FORM APPROVED
OMB NO. 1004-0135
Expires: July 31, 2010**SUNDRY NOTICES AND REPORTS ON WELLS**
*Do not use this form for proposals to drill or to re-enter an abandoned well. Use form 3160-3 (APD) for such proposals.***SUBMIT IN TRIPLICATE - Other instructions on reverse side.**

¹ API Number 30-015-28671	² Pool Code 47545	³ Pool Name Nash Draw; Brushy Canyon
⁴ Property Code	⁵ Property Name Gold Rush 30 Federal	⁶ Well Number 3
⁷ OGRID No. 229137	⁸ Operator Name COG Operating LLC	⁹ Elevation 3116'

**Gold Rush 30 Federal 3
30-015-28671
COG Operating, LLC.
May 05, 2014
Conditions of Approval**

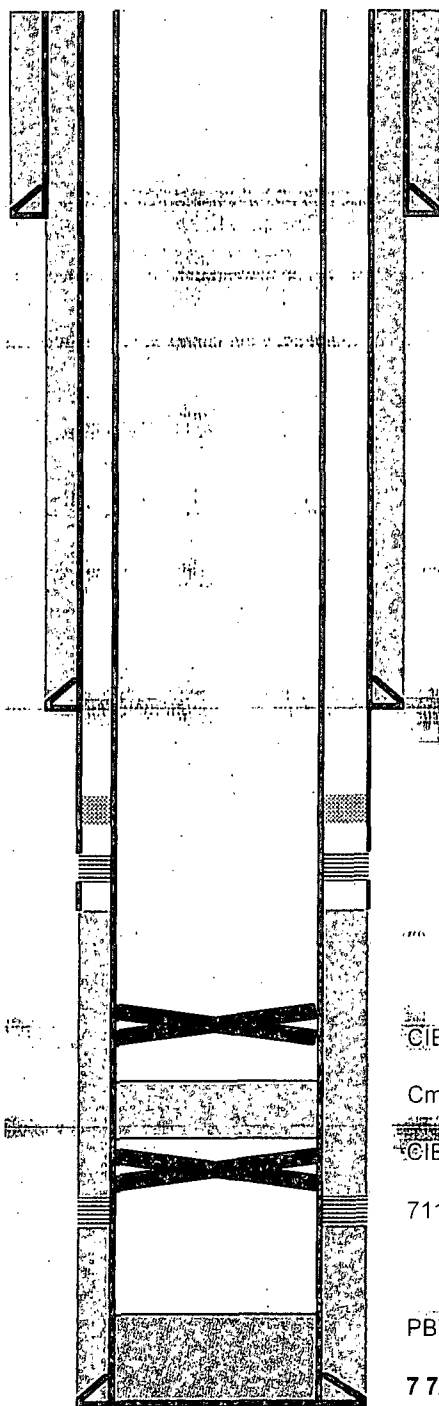
Set a CIBP @ 7100? 7069

Set CIBP @ 4500?

CIBP @ 4500'

Cmt plug 7050'-7100'

CIBP @ 7100'

- 1. Operator shall set a CIBP at 7,069' and place 25 sx Class C cement on top. Tag required at a minimum of 6,898'.**
- 2. CIBP at 4,500' is okay.**
- 3. Must conduct a casing integrity test before perforating and fracturing. Submit results to BLM. The CIT is to be performed on the production casing to max treating pressure. Notify BLM if test fails.**
